From: Warren Hansen <WHansen@chartwell-consultants.com>
Sent: Thursday, October 10, 2013 10:23 AM
To: Cosgrove, Brenda S FLNR:EX
Cc: Medeiros, Manuel FLNR:EX; Nunn, Chris FLNR:EX; Turner, Ryan
Subject: RE: A90213 - Block EM203 Retention Modification
Attachments: Removal of Retention D - Map.pdf

From: Nunn, Chris FLNR:EX
Sent: Tuesday, October 8, 2013 10:59 AM
To: Turner, Ryan; 'Warren Hansen'
Cc: Medeiros, Manuel FLNR:EX; Cosgrove, Brenda S FLNR:EX
Subject: A90213 - Block EM203 Retention Modification

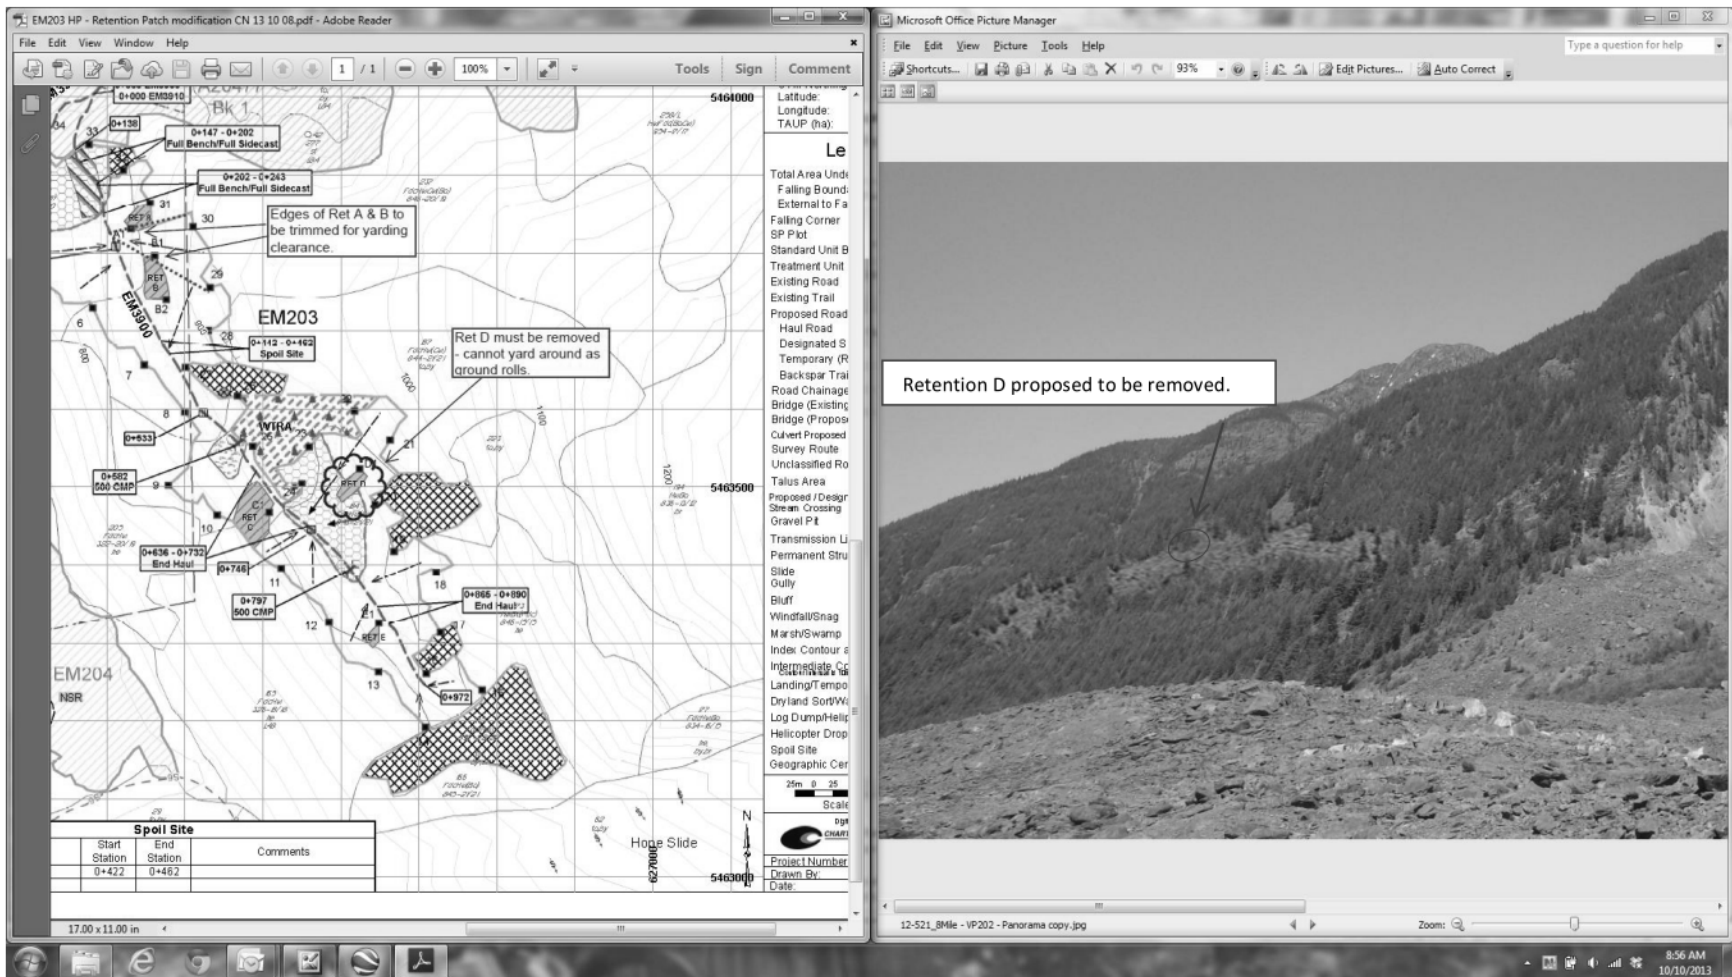
I've reviewed the Chris's map and concur with most of the edits suggested by Chris to Retention A/B. I am concerned however, with the full removal of Retention D. The VQO in this area is Retention being that the district is managing for a higher level of visual diligence around the Hope Slide. The definition of the Retention objective are openings to be difficult to see, small in scale, and natural in appearance. The layout of the block reflects the definition standards i.e. the block is limited in size, has a high level of retention and irregular boundaries. We are pushing the limits of the viewability of the block to facilitate the operational constraints of cable logging and block feasibility therefore I wrote a small rationale around the "Difficult to see" part of definition. Difficult to See parameters of typical Retention blocks would look like small slits in the canopy to most viewers. As such, Retention D was specifically put into place by me to break up the visual lines along top portion of the boundary therefore I am concerned that removing Retention D may increase the viewable area of a spikey bit along the top boundary and make the block easier to see. If I were to re-evaluate the given changes to the block, I would say that:

- given the large natural rock features such as the Hope Slide and adjacent scree slopes, we felt the block to be natural in appearance;
- the block is small in scale at around 0.75% (educated guess);
- the block is within the foreground of the viewpoint albeit to the side of the main viewpoint's focal point of the Hope Slide and in our opinion, makes the block easy to see therefore having Partial Retention features.

On Branch EM3900, they built a landing approximately where it should be as noted on the map. However the ground rolls and the boundary line appears to be slightly off in relationship to the landing location (maybe it was built 5 + metres out of optimum). As a result, they feel they will brush up against the edges of Retention Patches A and B. They

would like to remove a few trees on the edges to avoid the brushup. It should not impact the integrity of the retention patches significantly.

Further along, they have a real concern about Retention Patch D. Again they have the yarder location approximately where indicated on the map. However the retention patch is right in the middle of the yarding path. They cannot move the yarder NW along the road as the ground rises quickly into a knob. Moving the yarder to the SE will only make it worse. They would like to remove the entire retention patch.

Tamihi has cited safety concerns about rubbing up against these retention patches and although they can work around some areas, these circumstances are unavoidable.

If these retention patches were altered, how much will the visual analysis be changed?

I have talked to the contractor and they have a yarder on site, waiting to work. Since another analysis will not tell us much more at this point, I have asked the contractor to try to yard around Retention Patch D as best as they can. Once they are done, we can take another look and decide if we need another VIA done. Since the block has been felled, allowing them to proceed with caution is our only viable option. They may be able to retain most of it which is the best case scenario. If they have to remove it, then at least we can say we tried. If we had you re-analyze the block without the retention now and they ended up retaining part of it, we may have to run the analysis again.

We will monitor the logging in this block and evaluate after harvest. I will probably ask you to re-run your analysis post harvest.
